RE: 835 Commercial Street SE /Ref#: 22-117603-PLN (Class 3 Site Plan Review)

The following is a response to your plan review letter dated 10-04-2022

IMS-18

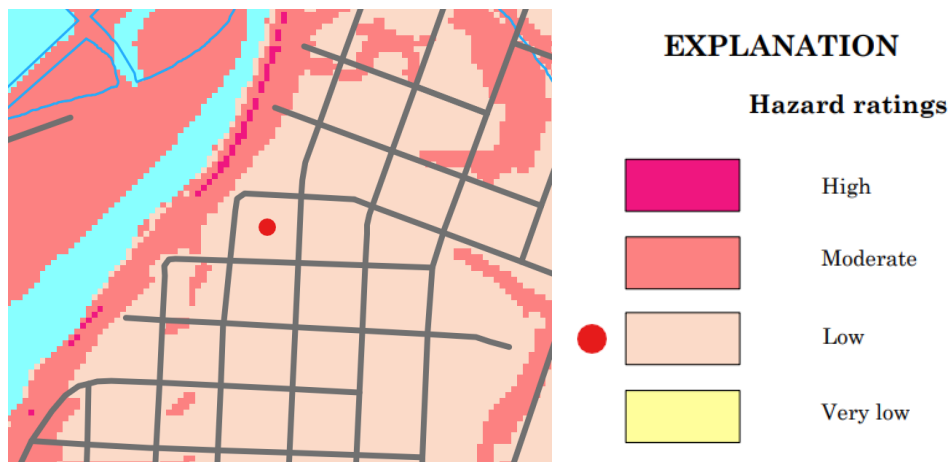
The topography of the property is flat. There are, however, three small areas of mapped landslide hazard susceptibility located on the site (see image below). Because of this, a geological assessment or a certification from an engineering geologist or a geotechnical engineer that landslide risk on the site is low, and that there is no need for further landslide risk assessment, is required.

Ron Derrick PE, GE of Branch Engineering Inc will be providing a geo technical report, if necessary. Based on the report below it does not seem necessary. The area you identified were planter. They have been removed.

TABLE 810-1A. EARTHQUAKE-INDUCED LANDSLIDE SUSCEPTIBILITY RATINGS

Property identified under very low or low categories on IMS-18.

ASSIGNED POINT VALUE = 0
